ADDENDUM

Date Issued:	Feb 21, 2024
Project:	Intermountain Health Intermountain Kidney Services – West Valley Dialysis 2750 South 5600 West West Valley City, UT 84120
Addendum Number:	1

Date: 2/20/24
Project No: 22249
Project: IKS West Valley Dialysis
Revision: Addendum #1

Finish
Schedule &
Details

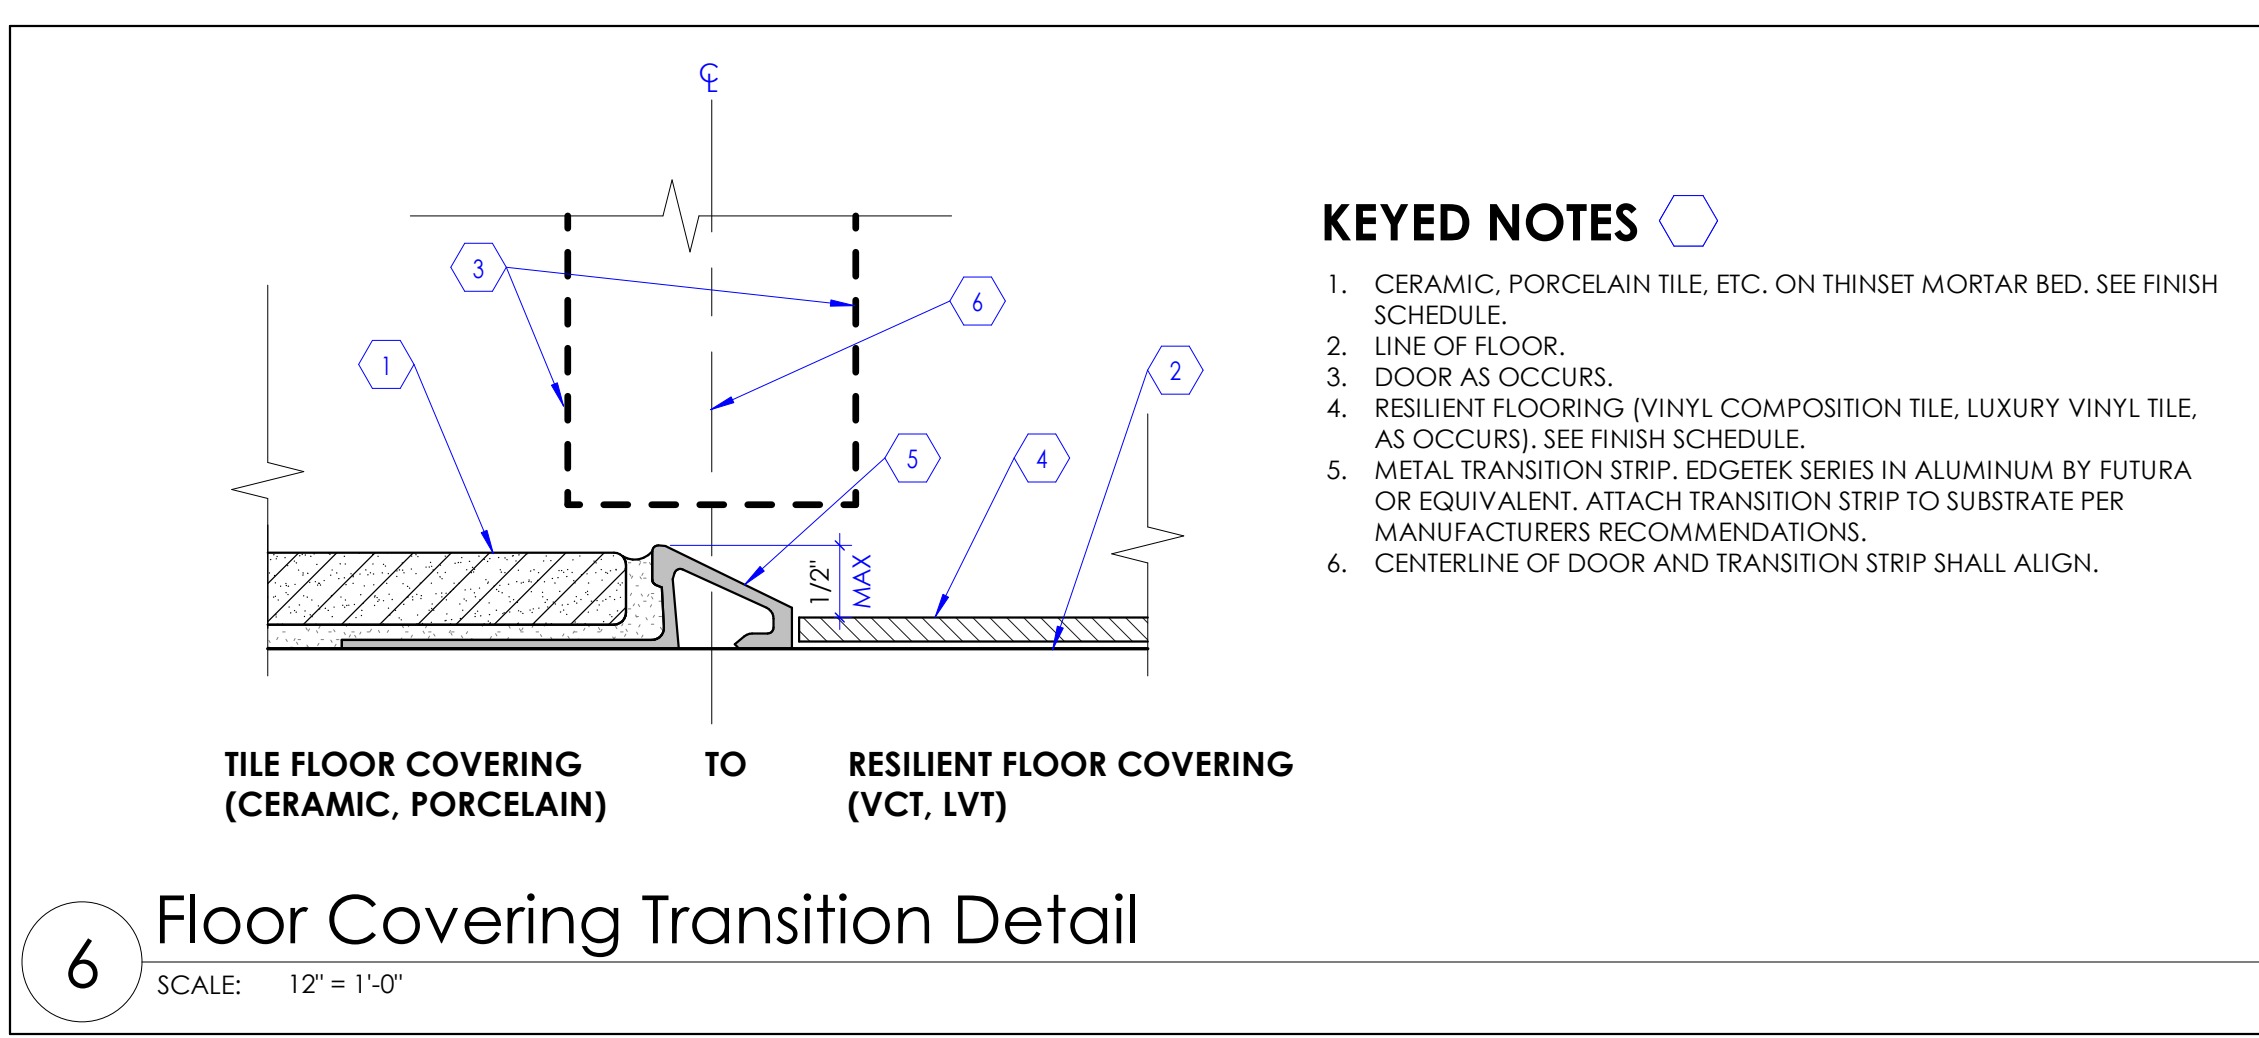
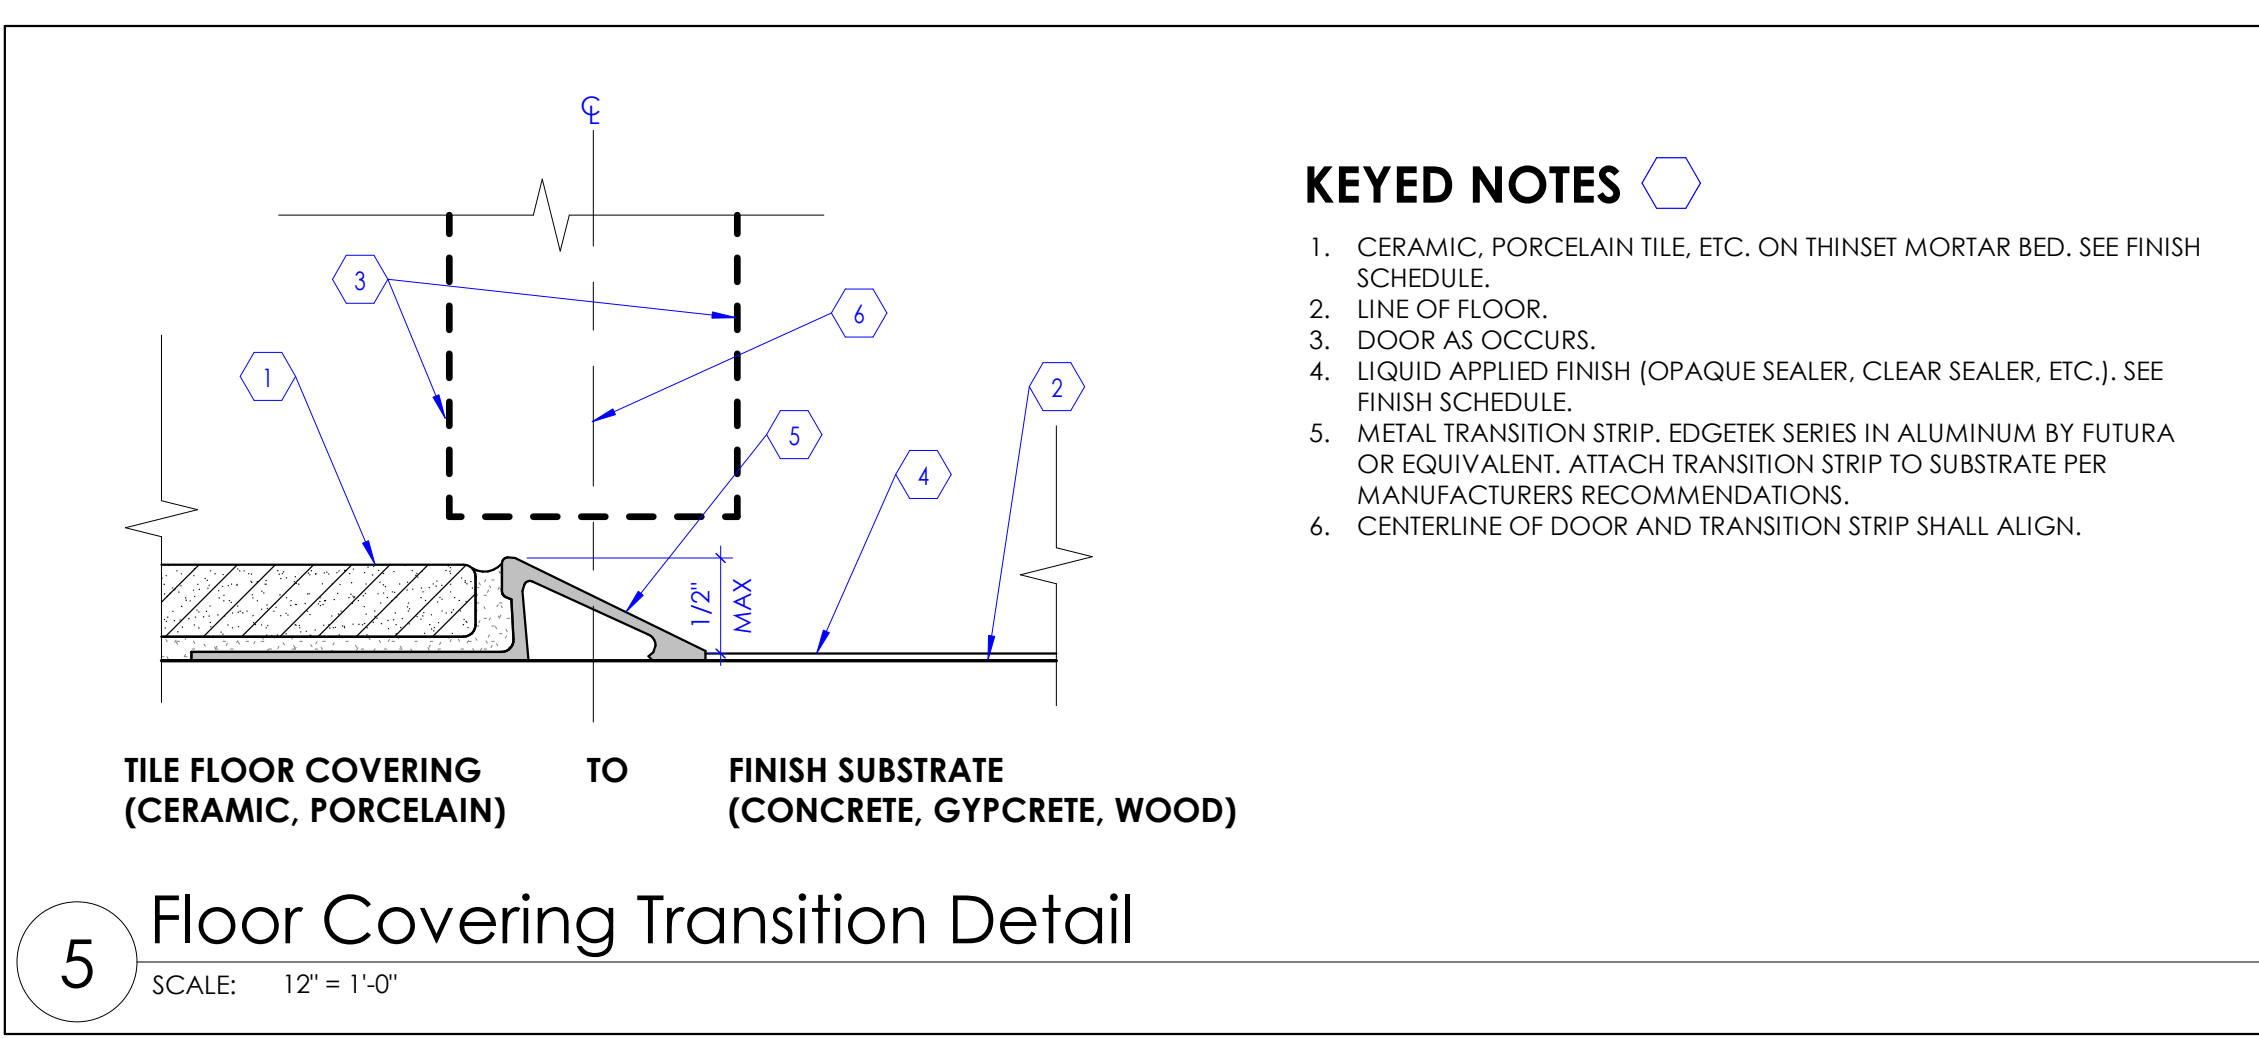
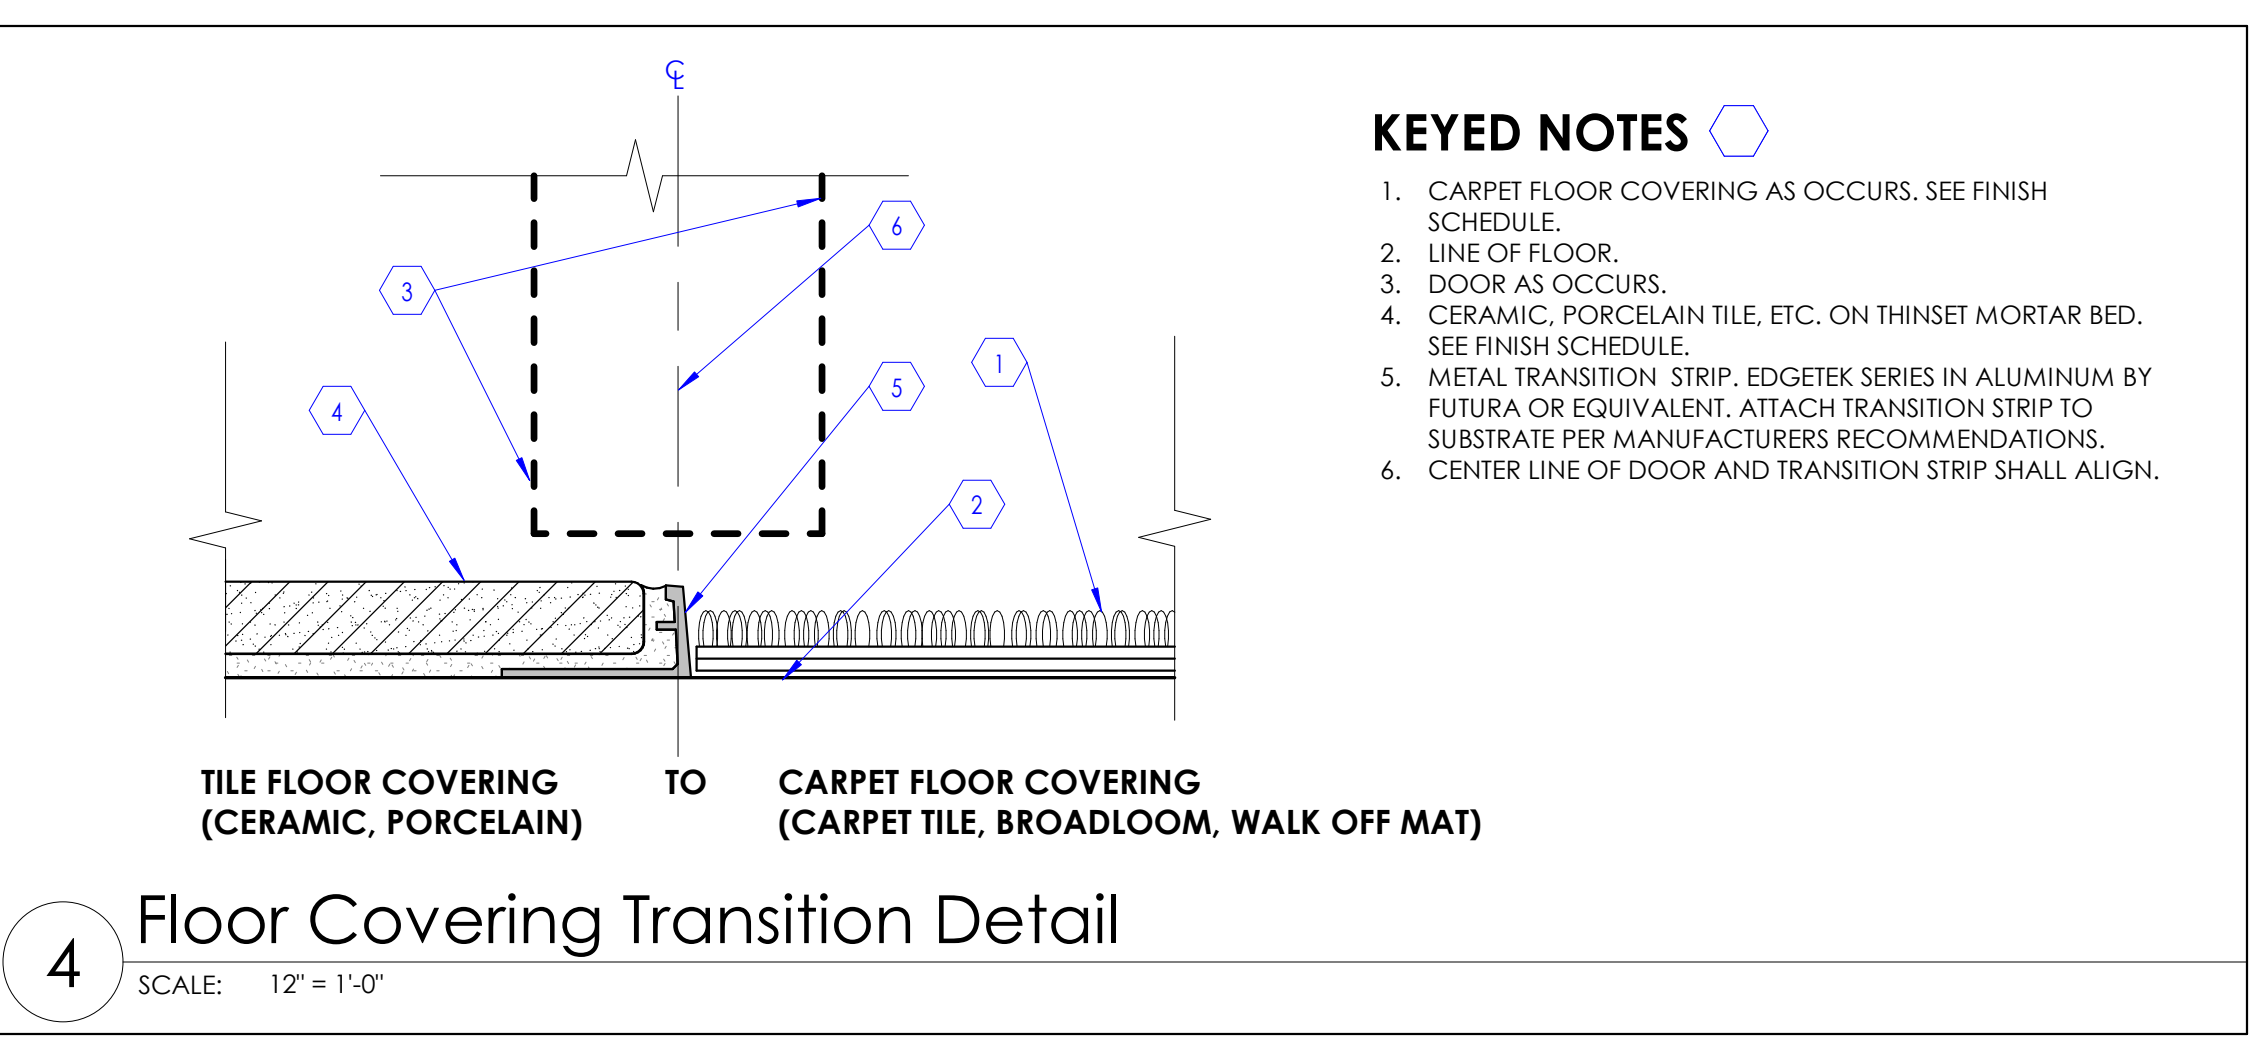
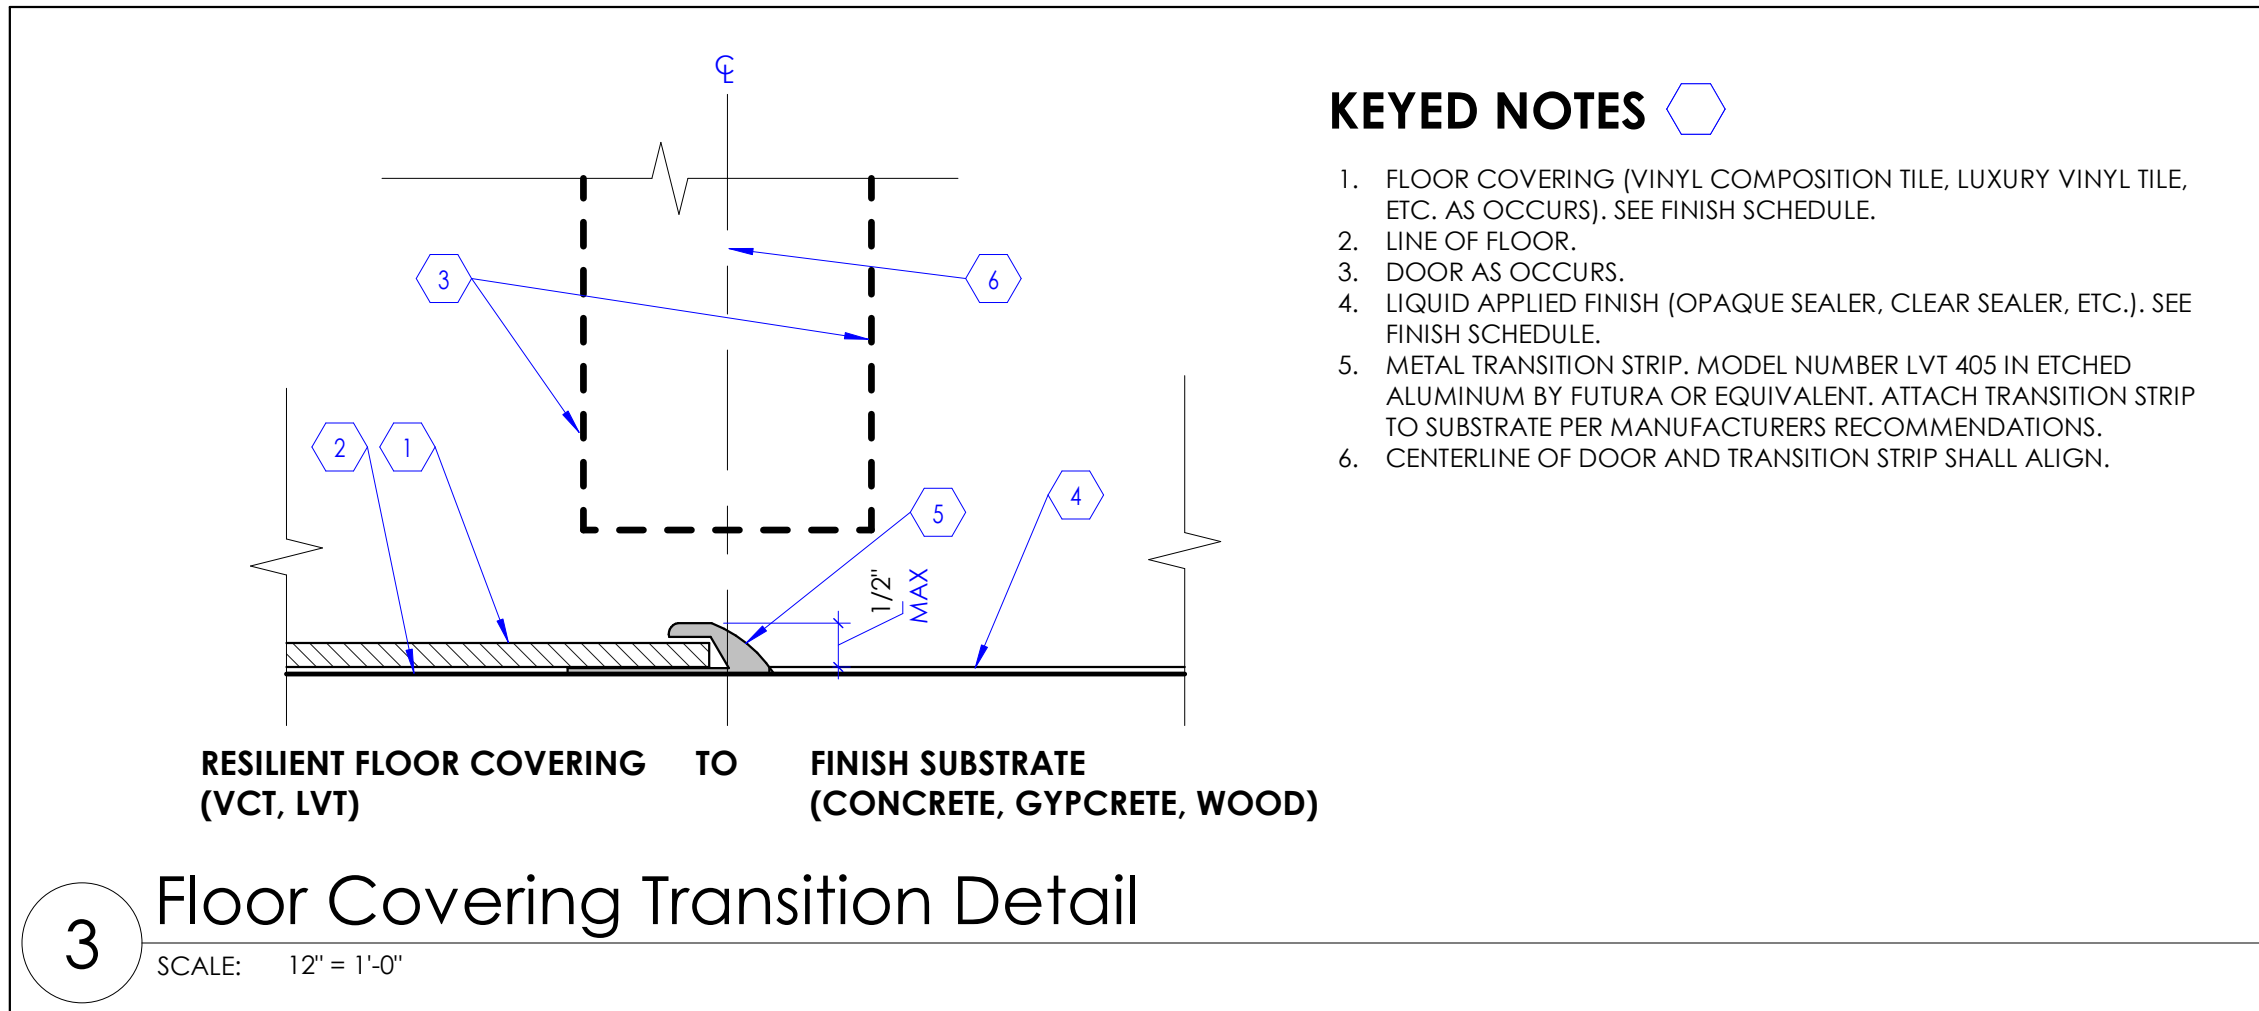
Item Number	General Items Description
	<p>Response: The one by the maintenance bypass is incorrect – the maintenance bypass is also OFCI as noted on the plan. UPS is OFCI – owner furnished, contractor installed. The keynote has been removed in Addendum #1.</p> <p>Question #6: One-line diagram is showing main breakers in all new panels but the panel schedules are calling Main Lug Only please clarify which will be required.</p> <p>Response: The man breakers shown in panels 1L1, 1L2, 1LE1, and 1LE2 are not required; these have been removed in Addendum #1.</p> <p>Question #7: The lighting control panel schedule doesn't show any of the circuits as dimming. Is this correct?</p> <p>Response: This is correct – this is not a dimming panel; dimming is by local switches where indicated in plan.</p> <p>Question #8: The tiles called out come in both honed and unpolished and do not specify which one. Can you please clarify? I noticed there was no tile trim or schluter called out on the plans, am i missing something or is it to be determined? thanks Will we be putting a schluter trim in any locations?</p> <p>Response: All of the ceramic tile should be the honed finish. As for the tile trim, we call that out in our spec. Section 093000 Tiling 2.13 Miscellaneous Materials K. 1. We have added clarifying information to the comments on the finish schedule.</p>
